# Access Compliance Report

## Public Rights-of-Way

### (Island Curb Cuts)

Intersection ID: 10035076	Main Street: PROVIDENCE_RD	Cross Street: HEATHERWOODS APARTMENT DR	Location: E
ADA ID: EC7F3BE9DC8B	Curb Cut Type: MedianRefuge2	Initial Pass/Fail: Fail	Overall Compliance: No
		Severity Score: 21.25

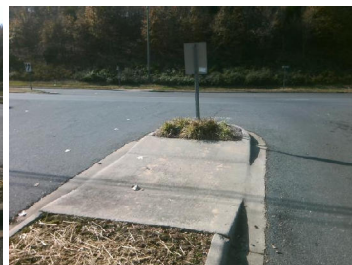
Compliance	Description	Data	Compliance	Description	Data
Yes	Refuge 1 Length (In)	44.5	N/A	Gutter 1 Ponding?	N/A
No	Refuge 1 Width (In)	48.0	N/A	Gutter 1 Lip Ht (In)	N/A
Yes	Refuge 1 Slope (%)	0.1	N/A	Gutter 1 Slope (%)	N/A
No	Refuge 1 X Slope (%)	7.8	N/A	Gutter 1 X Slope (%)	N/A
N/A	Painted X Walk1?	No	N/A	DWS 1 Provided?	N/A
N/A	X Walk 1 Direction	To N	N/A	DWS 1 Contrast?	N/A
N/A	X Walk 1 Width (In)	N/A	N/A	DWS 1 Length (In)	N/A
N/A	Road 1 Slope (%)	8.2	N/A	DWS 1 Full Width?	N/A
N/A	Road 1 X Slope (%)	3.1	N/A	DWS 1 Offset (In)	N/A
Yes	Refuge 2 Length (In)	44.5	N/A	Gutter 2 Ponding?	N/A
No	Refuge 2 Width (In)	48.0	N/A	Gutter 2 Lip Ht (In)	N/A
Yes	Refuge 2 Slope (%)	1.2	N/A	Gutter 2 Slope (%)	N/A
No	Refuge 2 X Slope (%)	9.9	N/A	Gutter 2 X Slope (%)	N/A
N/A	Painted X Walk2?	No	N/A	DWS 2 Provided?	N/A
N/A	X Walk 2 Direction	To S	N/A	DWS 2 Contrast?	N/A
N/A	X Walk 2 Width (In)	N/A	N/A	DWS 2 Length (In)	N/A
N/A	Road 2 Slope (%)	9.1	N/A	DWS 2 Full Width?	N/A

**Remove & Replace Entire Refuge.**
